# SR 92 REALIGNMENT AND WIDENING

## Value Engineering Study Report

Preliminary Design Stage

May 2008

ALTERNATIVE NO.  
HA-R-11  
ORIGINAL DESIGN  
SHEET 2 OF 5

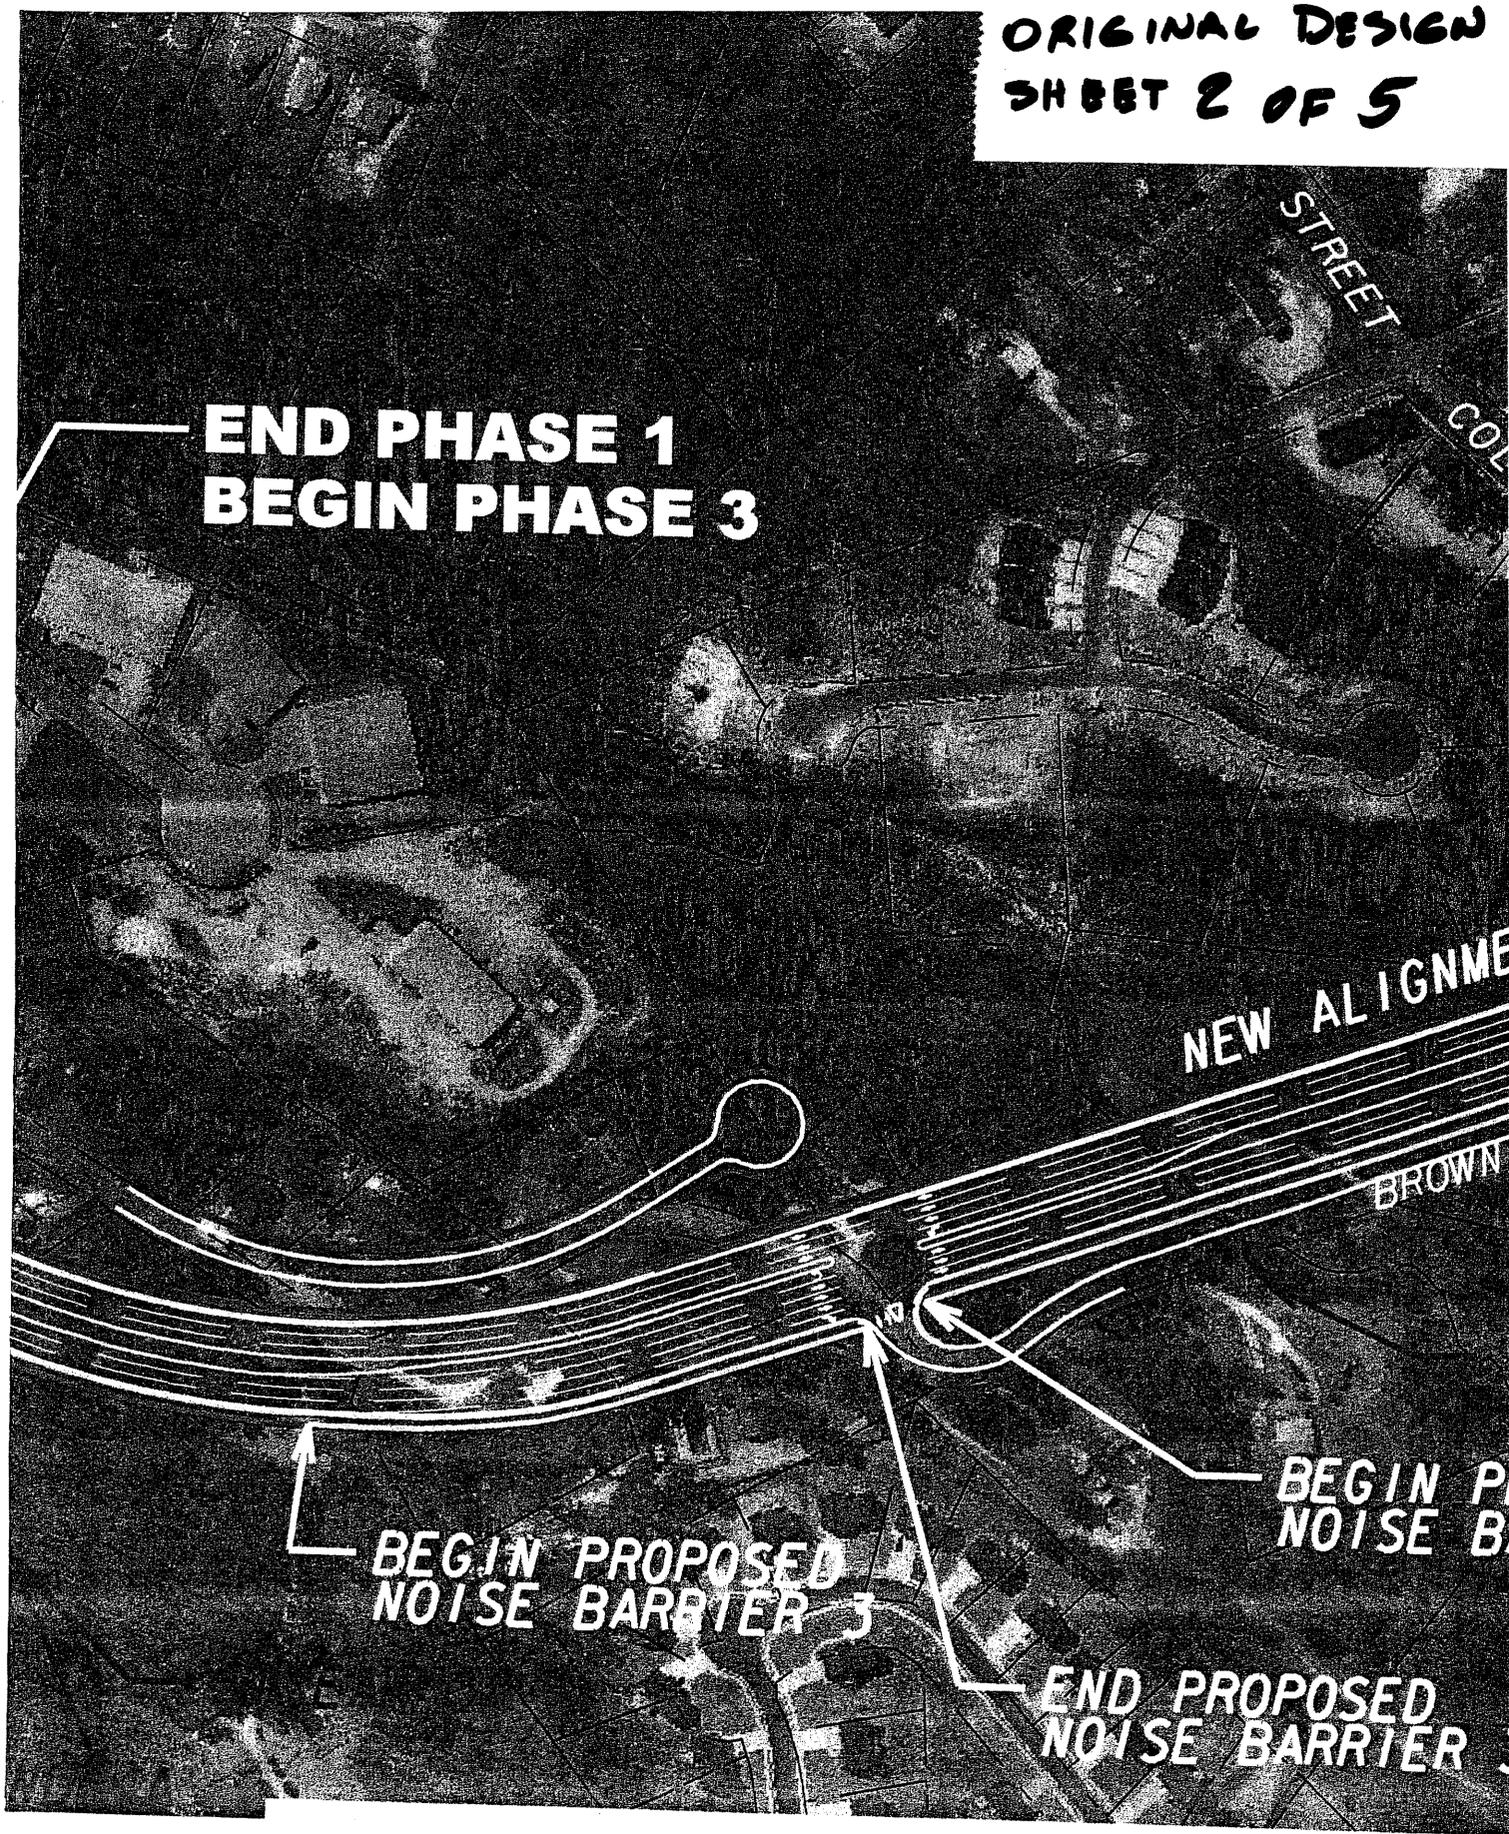
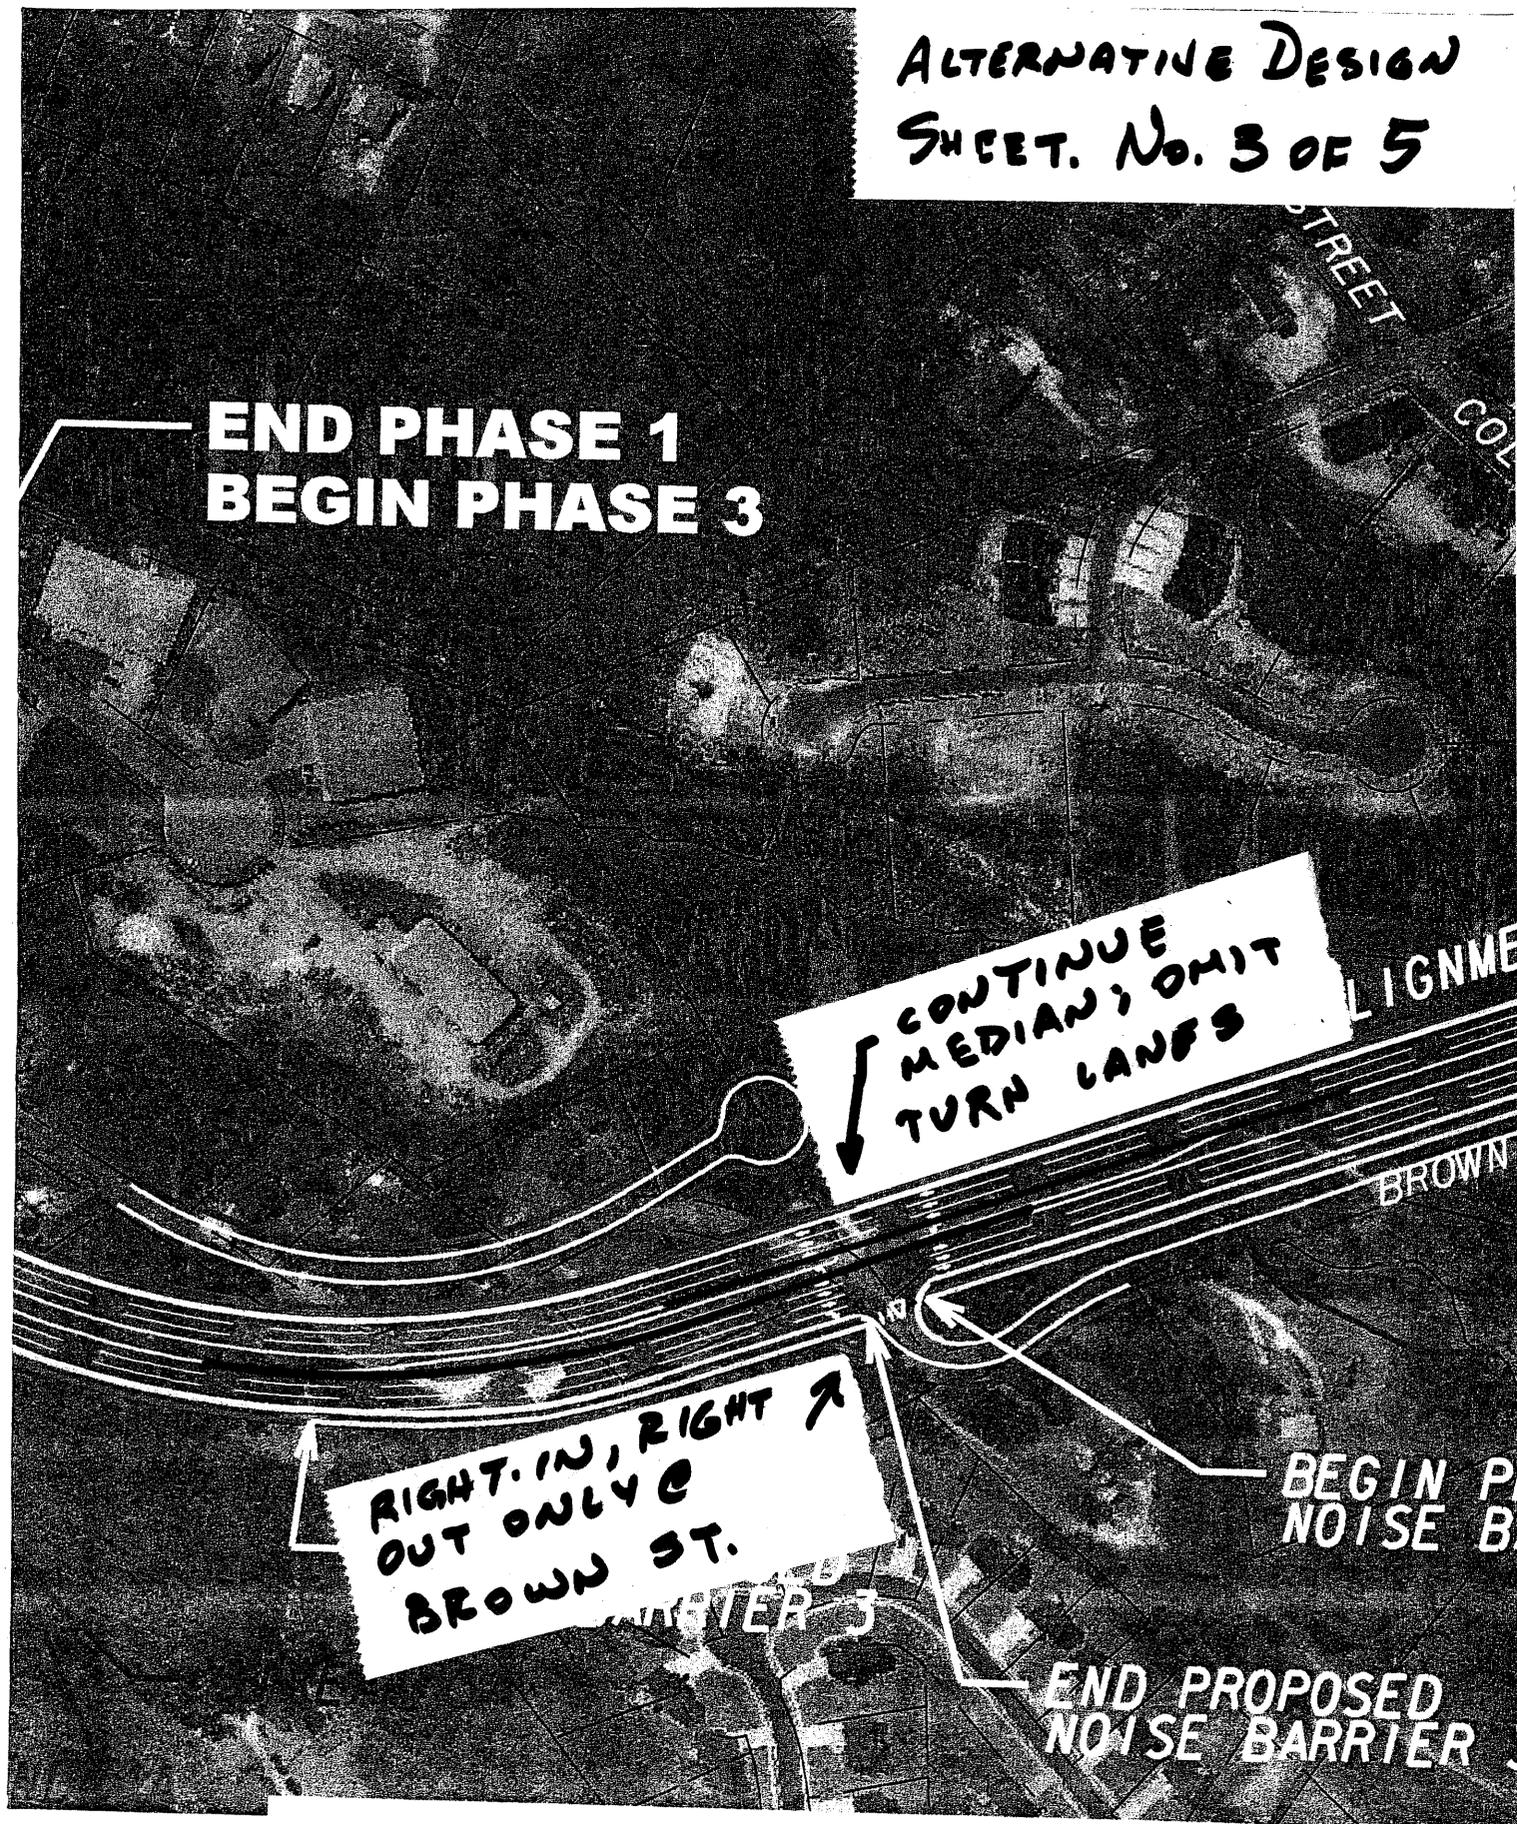
The current design allows left and right turns into and out of Brown Street. The Brown Street intersection is approximately midway between Ellis and Colquitt Streets and is not signalized. Eliminating left turns in or out of Brown Street could retain access for residents with highway safety improvements. Southbound traffic on SR 92 would continue to Ellis Street and make a U-turn to access Brown Street. Traffic leaving Brown Street and desiring to go south on SR 92 will go north to Brown Street and make a U-turn. Each of these will add about one-half mile to the trip.

CONTINUE  
MEDIAN; OMIT  
TURN LANES

ALTERNATIVE DESIGN  
SHEET. No. 3 OF 5

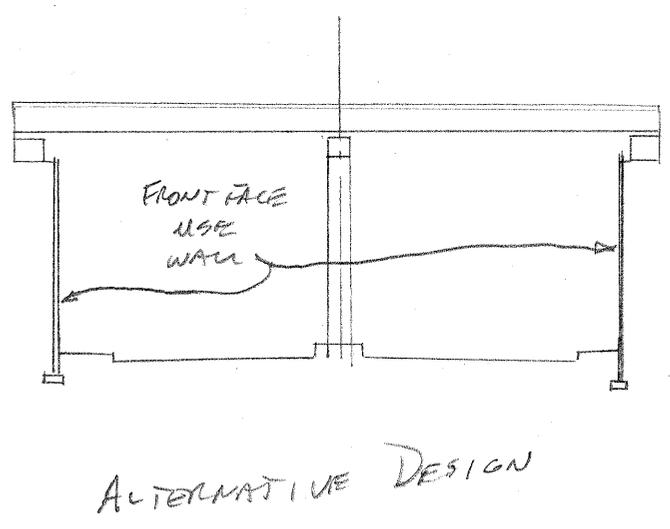
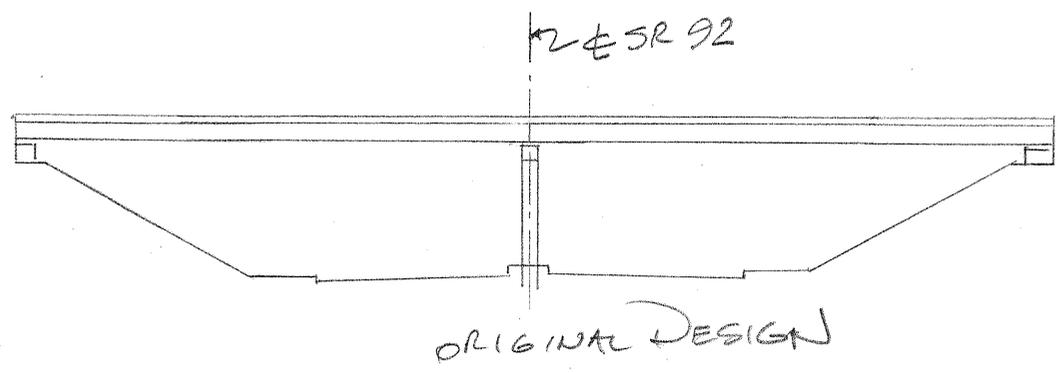
- Requires more complex bridge construction at the walls
- Requires reconstruction of bridges if SR 92 is widened in the future

Shortening the bridges by using retaining walls removes the cost and construction time associated with longer spans.
